**Annex 1 Letter from Fisheries and Oceans Canada to the Agency,
March 15, 2016**

Subject: DFO Comments on the Agencies March 2nd and 7th, 2016 Information Requests for the Pacific Northwest LNG Project.

**DFO response to CEAA's March 2nd and 7th 2016
Requests for Information**

**Science response to CEAA request re: updated hydrodynamics
information and questions from external participants regarding
inadequacies in the modeling**

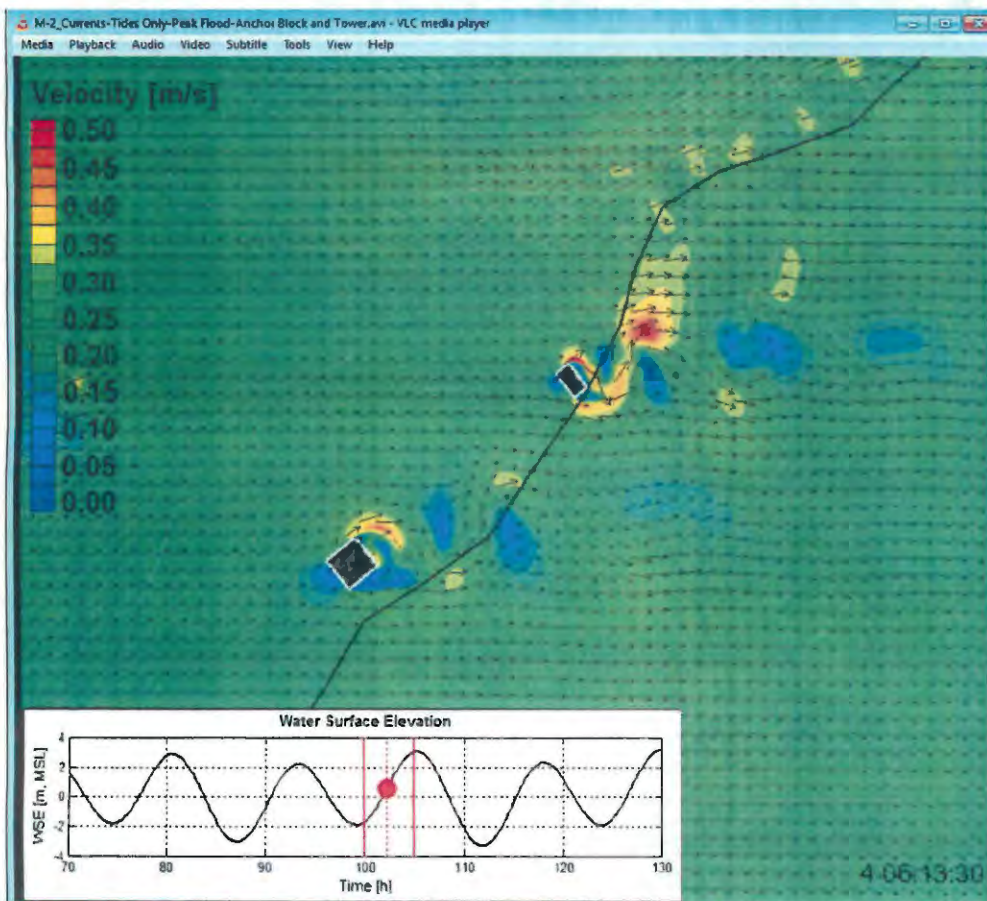
The advice that DFO provided on the potential impacts of the SW Tower and SW Anchor Block (DFO 2016), was largely based on the high resolution simulations using the MORPHO model. A snapshot of the simulated current field during flood tide with the SW Tower and SW Anchor Block in place is provided below.

The figure shows tidal currents of 20-30 cm/s (green) over much of Flora Bank. One can also see eddies being shed from the two marine structures (the blues and the yellow/red).

- The new ADCP data provide clear evidence that the currents from the Delft-3D simulations have appreciably smaller speeds than observed currents over the shallow part of Flora Bank.

- The advice that DFO provided on the potential impacts of the SW Tower and SW Anchor Block with respect to scour, total suspended solids, and changes in currents in the vicinity of the structures, does not need to be revised in light of this new information as uncertainties in the currents were taken into account in developing this advice. However, should background tidal currents speeds be shown to be 40 or 50 cm/s, then the advice would need to be revised.
